M9802A-03

Information Only Service Note

M9802A PXIe Vector Network Analyzer

False alarm on self-test failure on firmware revision of A.13.40.02 - DDR3 memory removal

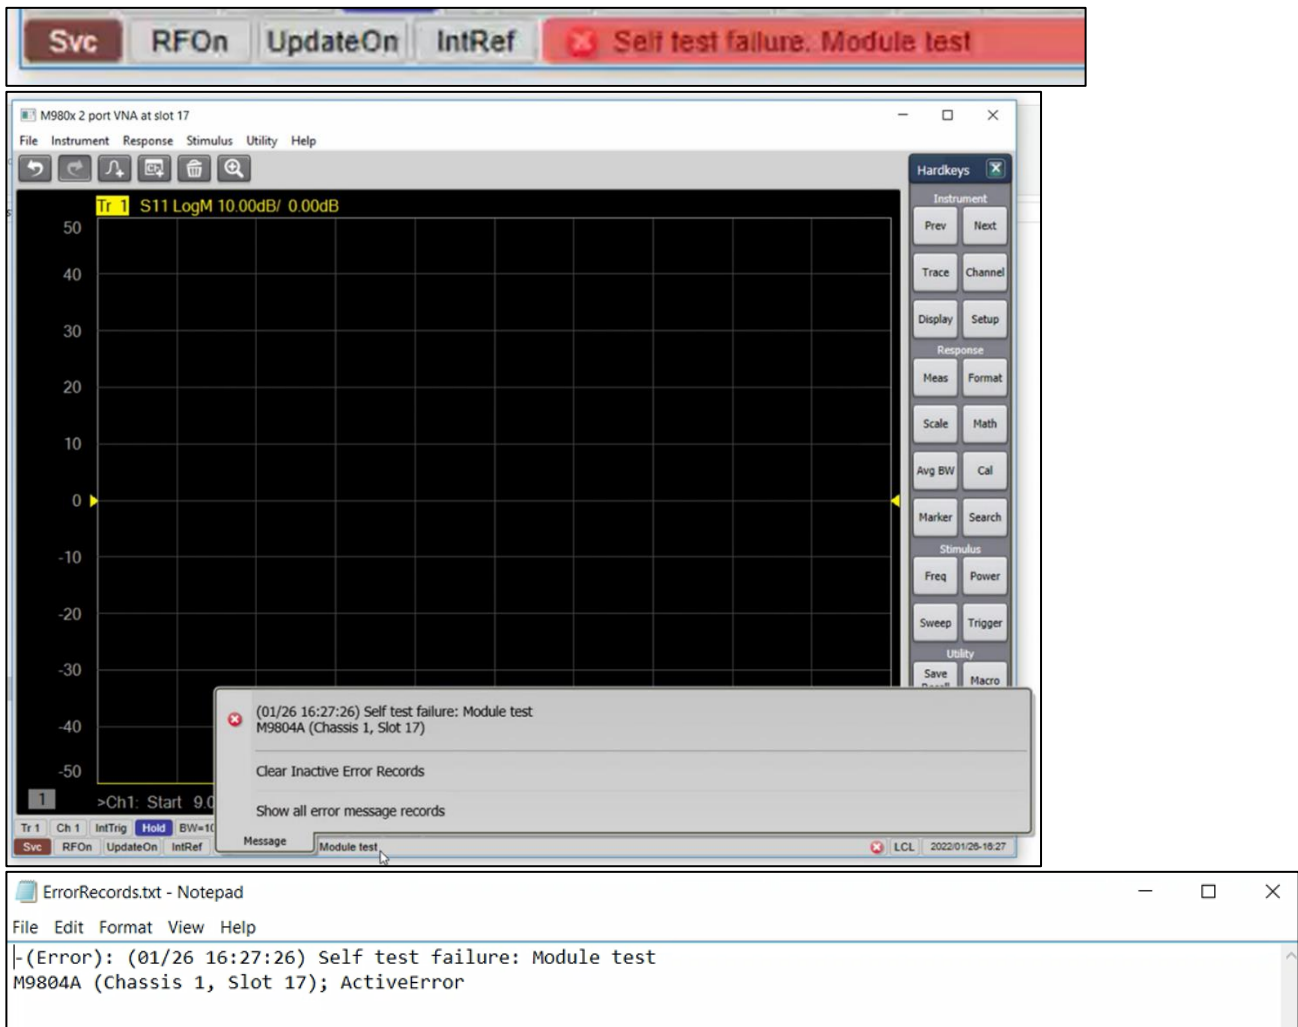
The on board DDR 3 memory in VNA is not in use since its release. With the removal of DDR 3 memory IC on newer M980xA VNA, right after firmware is launched, false alarm (self-test failure) will be reported as shown. This has no impact to VNA performance and specifications.

Similarly, firmware will report a false failure in Operator check. Shown are the error messages example on VNA firmware UI.

Since this DDR3 memory is not in use, newer firmware revision no longer consider it as the failure. Keysight recommends keeping VNA firmware up-to-date whenever it is possible.

For users with firmware revision of A.13.40.02,
Update firmware to revision A.13.70.02 or newer to resolve this false alarm on self-test.
